VERIFICATION REPORT

3rd Periodic Verification of
**Xiaogushan Hydropower Project in
People's Republic of China**

CDM Reference No. 0378

Report No. GR09W0011D

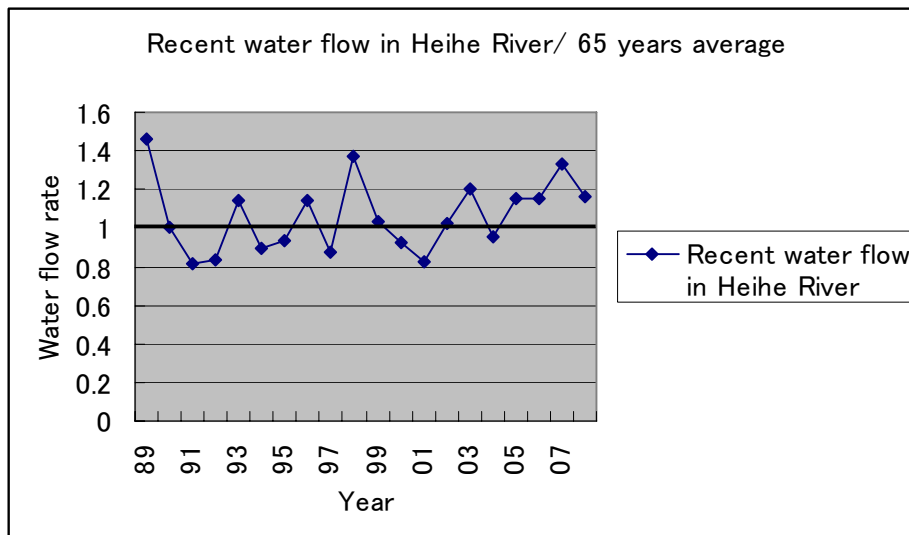
Calculated CERs in the year of 2008 is 374,039 tCO₂ and approx. 117% of annual estimation of emission reduction in tCO₂e of the PDD (319,277 tCO₂e). The reason of this increase is to be clarified.

Major reasons of the increased CERs are as follows.

- (1) Water flow of Heihe River in 2008 was approximately 116.7% compared to the average year. By this increased water flow, the electricity generation in 2008 was larger than expected annual generation.
- (2) Good performance of the power station and achievement of higher availability than expected. The power station had been running smoothly throughout the year of 2008.

Verification team confirmed that above reasons are reasonable by the following assessment of the water flow statistics during 1944 to 2008 for the Heihe River and the performance record of the power plant. (/12a/, /12b/)

Average water flow of Heihe River = $158000 \times 10^4 \text{ m}^3 / \text{year}$ (1944 to 2008)

Water flow of Heihe River in 2008 = $184000 \times 10^4 \text{ m}^3$

$$\therefore 184/158 = 1.167$$
